Limerick Generating Station, Units 1 and 2
Renewed Facility Operating License Nos. NPF-39 and NPF-85
NRC Docket Nos. 50-352 and 50-353

Subject: Response to Request for Additional Information for
Application to Adopt TSTF-477, Revision 3, “Add Action for Two Inoperable
Control Room AC Subsystems” and Associated Technical Specification
Changes

**Response to Request for Additional Information
License Amendment Request**

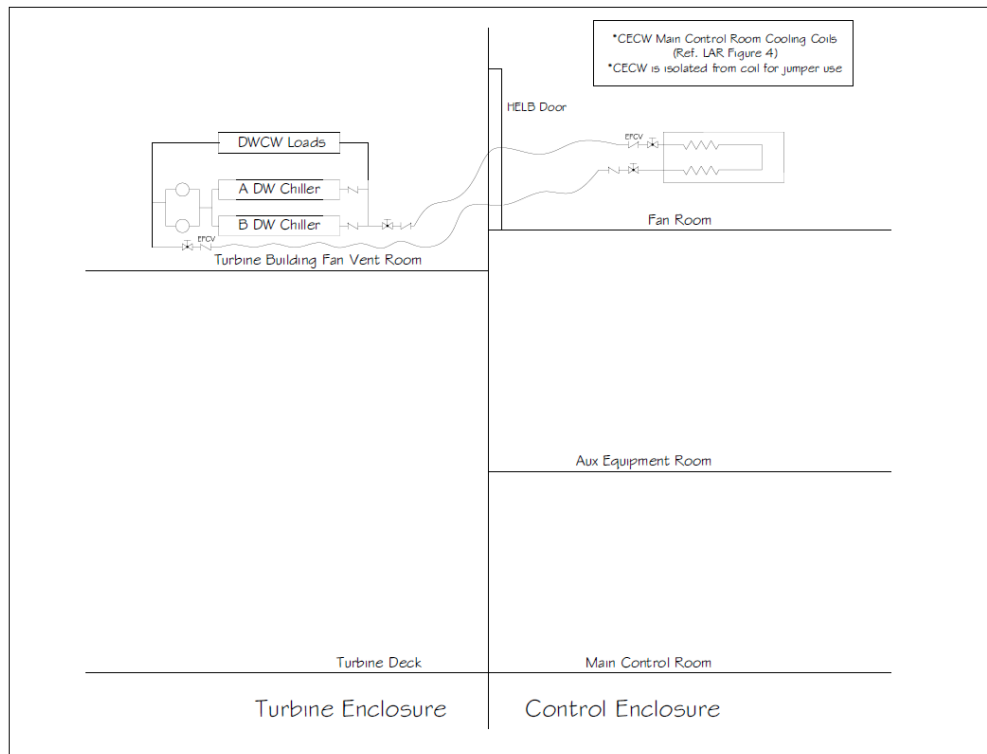
RAI-05 – Confirm whether all doors between the safety-related control enclosure, control room envelope, and nonsafety-related turbine enclosure are qualified HELB barriers. (Refer to Audit Question 2.)

- a. *Describe (e.g., via a simplified sketch or drawing) the temporary chiller water hose's (jumper's) proximity to the control room (including a description of where the jumper will be located and routed from the turbine enclosure to the control enclosure). (Refer to Audit Question 3.)*

All doors between the safety related control enclosure, control room envelope and non-safety related turbine enclosure are qualified HELB barriers.

Response: Simplified drawing (not a controlled drawing):

The DWCW cooling supply and return jumper connections are only installed on Unit 1. The Limerick primary means of temporary supplemental MCR cooling documented in the LAR utilizes cooling methods that do not breach the MCR envelope while in the LCO. Opening MCR doors that breach the MCR envelope during normal operating conditions is not an effective temporary cooling provision, because the steady state turbine deck temperature is 105°F during warm weather conditions. This would accelerate MCR heat up and negate temporary cooling efforts.
